## YZ125H CHAIN GUIDE

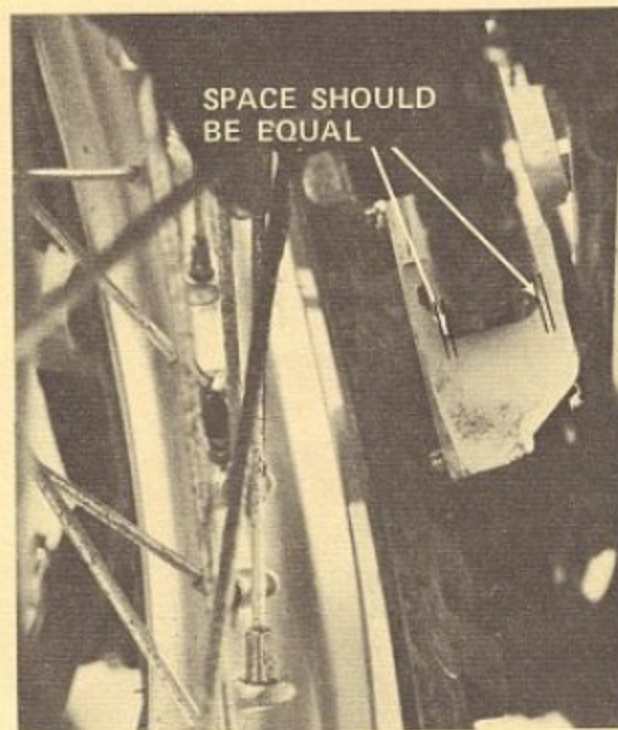
The chain guide on some of the affected models is not properly aligned with the chain. As a result of this misalignment, the chain hits the guide and falls off the driven sprocket during operation. To avoid this problem, inspect the chain guide on each affected model during predelivery. If the guide is not properly aligned with the chain, carefully bend the chain guide bracket until the chain runs through the middle of the guide.

1. Rap the chain guide with a plastic mallet, and bend the chain guide bracket towards the frame. Apply the minimal force needed to bend the chain guide in line with the chain. Be sure the chain runs through the middle of the chain guide as shown in the photograph.
2. Instruct your customers to inspect the chain guide after each race. Rocks or other debris can bend the chain guide.
